NATURE OF REVISION R-4

KANSAS MINE NO. 2
ASMC P-3936

PERMIT MAP, R-4

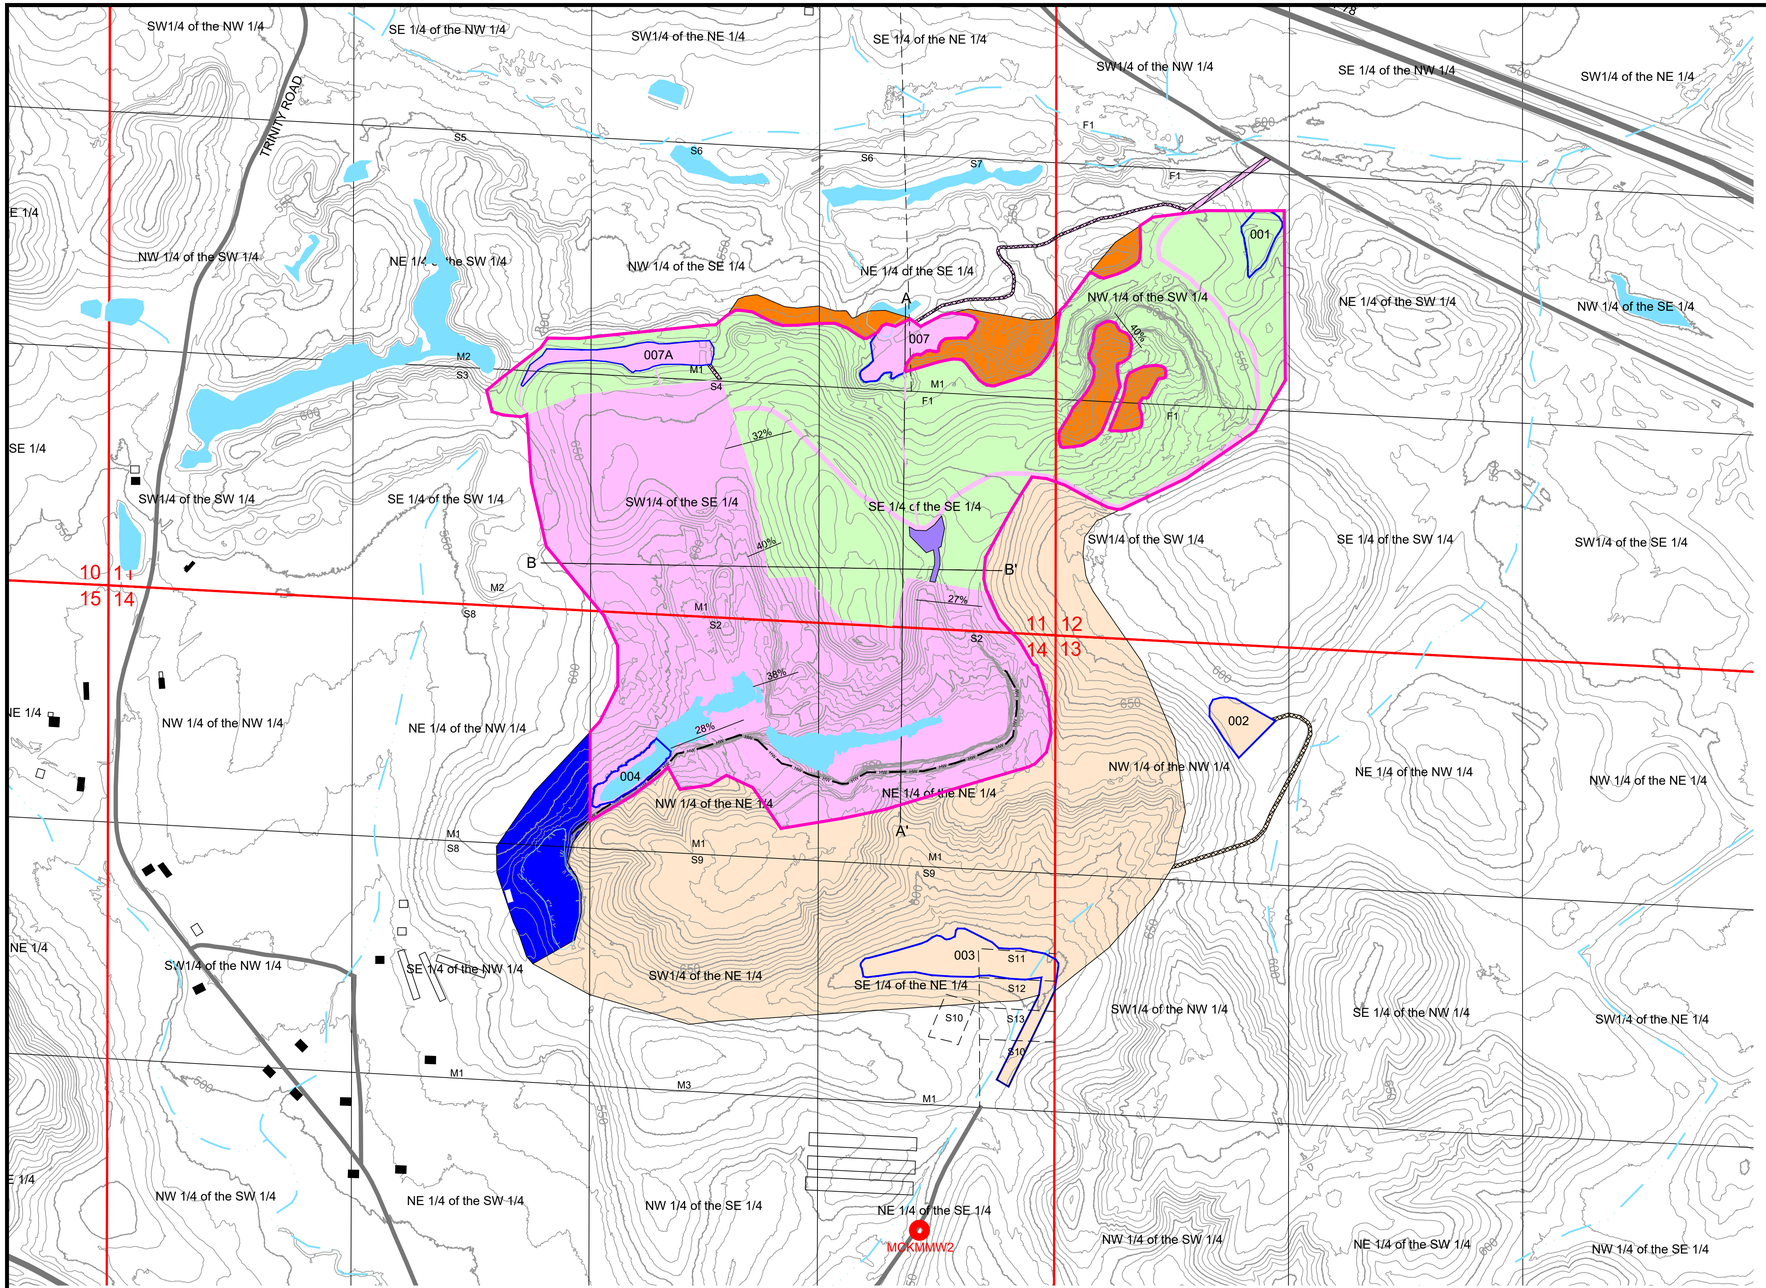
1. DELETE 116 MINING ACRES, SEDIMENT BASIN 002, SEDIMENT BASIN 003, AND ACCESS FROM INCREMENT NO. 3 AS UNDISTURBED.
2. DELETE 9 MINING ACRES FROM INCREMENT NO. 1 AS UNDISTURBED.
3. DELETE 12 MINING ACRES FROM INCREMENT NO. 2 AS UNDISTURBED.
4. TRANSFER 0.4 MINING ACRES FROM INCREMENT NO. 2 TO INCREMENT NO. 1 (NO ACREAGE CHANGE).
5. ADD SEDIMENT BASIN 004 TO INCREMENT NO. 1 (NO ACREAGE CHANGE).
6. CHANGE THE POST MINING RECLAMATION SLOPES.
7. MODIFY THE GENERAL PLAN.
8. UPDATE THE HYDROLOGIC MONITORING PLAN.
9. CHANGE THE POST MINING LANDUSE OF SEDIMENT BASIN 001 (INCREMENT NO. 2) AND SEDIMENT BASIN 007A (INCREMENT NO. 1) FROM TEMPORARY (UNDEVELOPED/NO CURRENT USE) TO PERMANENT (FISH & WILDLIFE).

INCREMENT NO. 1	
MINING AREA	94.0 ACRES
PRIMARY ROADS	1.0 ACRES
ROUTE OF TRAVEL	4.0 ACRES
OFFICE, EQUIPMENT STORAGE, STOCKPILE AREA	ON SITE
SEDIMENT BASIN 004, 007, & 007A DRAINAGE COURSES, DIVERSIONS, & ACCESS	6.0 ACRES
TOTAL BONDED AREA	105.0 ACRES
INCREMENT NO. 2	
MINING AREA	85.0 ACRES
OFFICE, EQUIPMENT STORAGE, STOCKPILE AREA	ON SITE
SEDIMENT BASIN 001 DRAINAGE COURSES, DIVERSIONS, & ACCESS	1.0 ACRES
TOTAL BONDED AREA	86.0 ACRES
TOTAL PERMIT AREA	191.0 ACRES
